1958 Agreement – Consideration of draft amendments to existing Regulations submitted by GRE

Proposal for Supplement 9 to Regulation No. 99 (Gas-discharge light sources)

Submitted by the Working Party on Light and Light-signalling*

Paragraph 2.4.2., amend to read:

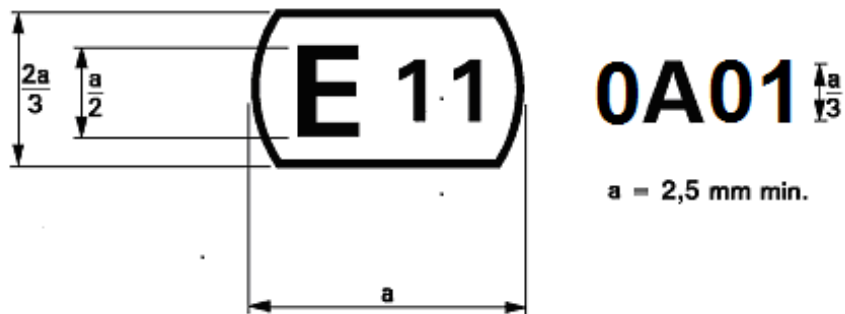
"2.4.2. ...

This will be followed by an identification code comprising not more than three characters. Only the Arabic numerals and capital letters listed in footnote (1) shall be used."
